ST75C520 REVISION 1.4

The purpose of this document is helping the customer to use the Revision 1.4 of the ST75C520. So the ST75C520 Revision 1.4 Application Guide answers some questions as :

Figure 1 : Detailed Timing Diagram

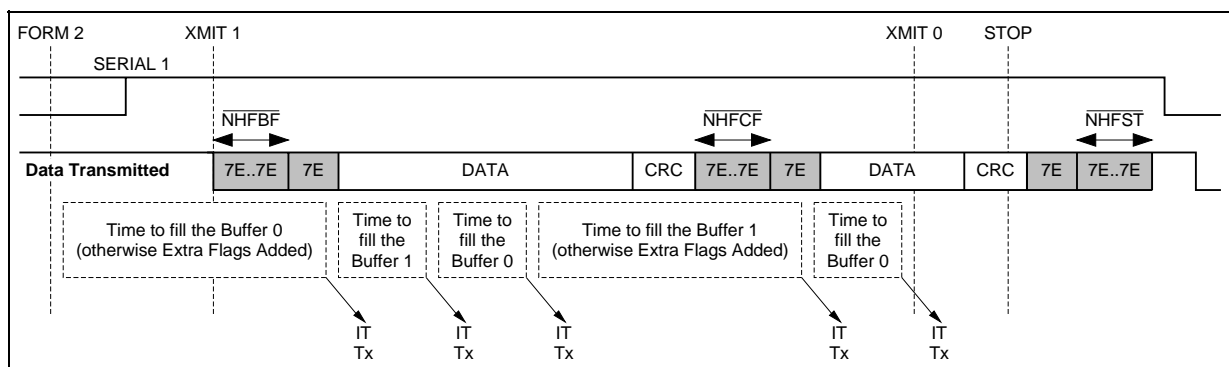
Three new global variables have been added in the Revision 1.3 to allow the programming of new 7E flags before the first frame, between the data frames and after the last frame :

- `_NHFBF`: Number of flags before the first frame.
- `_NHFCF`: Number of flags between frames.
- `_NHFST`: Number of flags after the last frame.

The default value for these three variables is 0. The programming range is from 0 to 7FFF (32767) (see Figure 1).

HP5	JAPAN Line patch	Feb 1, 96	Revision 1.2 to 1.4	p19
-----	------------------	-----------	---------------------	-----

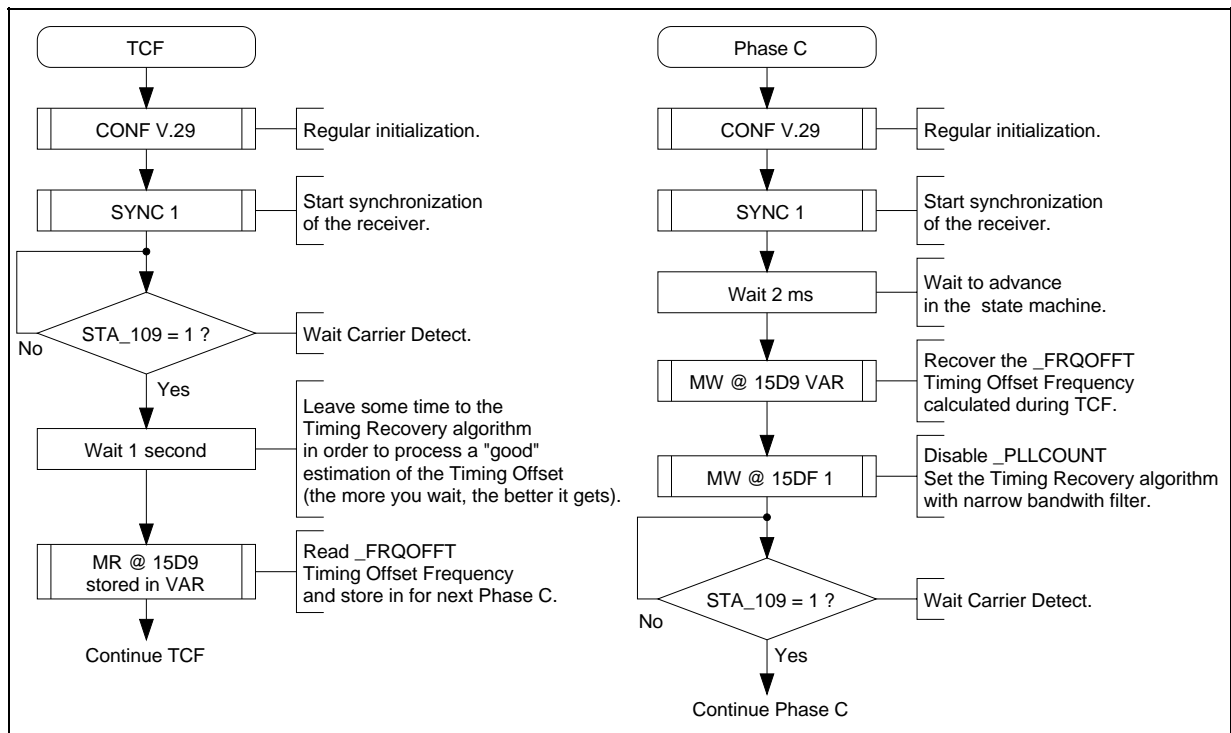
On JAPAN lines, the TPG (Group Delay) is asymmetrical between 600Hz and 3000Hz. And thus some wrong "dots" can appear at the top of received pages. That problem is related to the Timing Recovery algorithm.

The sequence is described in the following flow chart.
